LR-N99556
LCR S99-11

**REQUEST FOR CHANGE TO TECHNICAL SPECIFICATIONS
REACTOR TRIP SYSTEM INSTRUMENTATION
SALEM GENERATING STATION
UNIT NOS. 1 AND 2
DOCKET NOS. 50-272 AND 50-311**

**SALEM GENERATING STATION
UNIT NOS. 1 AND 2
FACILITY OPERATING LICENSES DPR - 70 AND DRP - 75
DOCKET NOS. 50-272 AND 50-311
CHANGE TO TECHNICAL SPECIFICATIONS**

**SALEM GENERATING STATION
UNIT NOS. 1 AND 2
FACILITY OPERATING LICENSES DPR – 70 AND DRP - 75
DOCKET NOS. 50-272 AND 50-311
CHANGE TO TECHNICAL SPECIFICATIONS
OVER TEMPERATURE AND OVER POWER DELTA TEMPERATURE
TECHNICAL SPECIFICATION PAGES WITH PROPOSED CHANGES**

TABLE 2.2-1 (Continued)

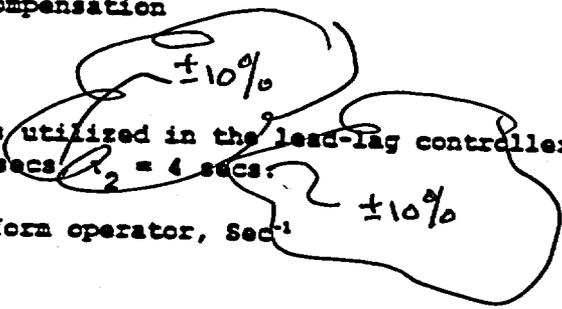
Note 1

τ_1 & τ_2 = Time constants utilized in the lead-lag controller for T_{avg}
 $\tau_1 = 30 \text{ secs } \underline{\pm 10\%}$, $\tau_2 = 4 \text{ secs } \underline{\pm 10\%}$

τ_1 & τ_2 = Time constants utilized in the lead-lag controller for T_{avg} $\tau_1 = 30$ secs, $\tau_2 = 4$ secs.
